From: [REDACTED]
To: [REDACTED]
Sent: 4/5/2021 8:30:39 AM
Subject: FW: O8W-PM 35217268, 35224712, 35224713 - Bucks Creek 1101 Phase 1,2&3 - Pre-Engineering Meeting

Subject: O8W-PM 35217268, 35224712, 35224713 - Bucks Creek 1101 Phase 1,2&3 - Pre-Engineering Meeting

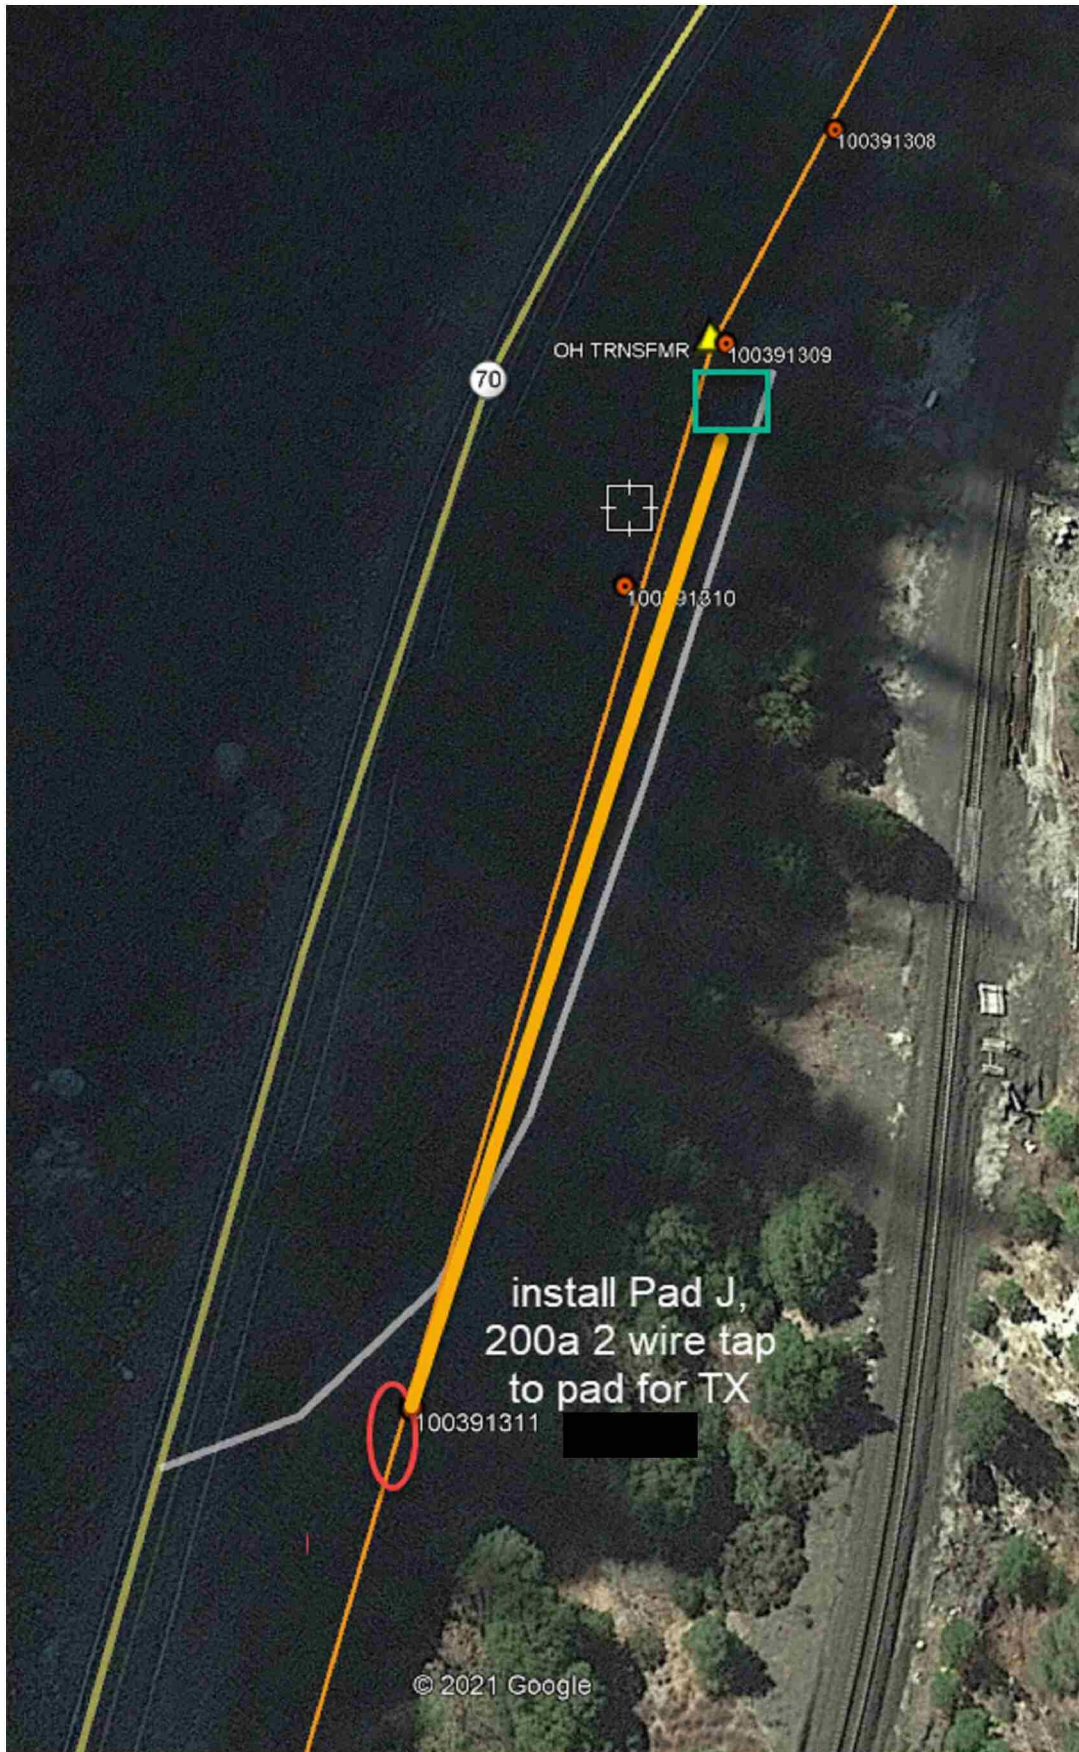
Your outlet red-line Bucks Creek looks close to what I was thinking. Need to work with [REDACTED] to get this designed with a single 6" and use #5 boxes with 200A cable. There is not a reason this will need (2) 6" and 1-4" and 7 boxes. There is probably only 20a peak on the primary now.

Before we involve Cal T and [REDACTED] it would be good to scope with the estimator so we can address the local folks with a somewhat solid plan. If we can establish the outlet for Bucks Creek Sub + the TX locations for Cresta Dam and [REDACTED] that should take most of the questions away. Rock Creek Bridge is the only thing I saw a big issue with. The local guys can help us once we determine what we are doing and make sure we get the details correct for permit.

Also need to see what Hydro is willing to do with the TX for the penstock metering valve at Rock Creek PH. It will be a long way up from the

Need to see if Hydro has GPR data for the Hwy 70 road bed to see if we can get 42" minimum cover and keep clearance over any hydro facilities.
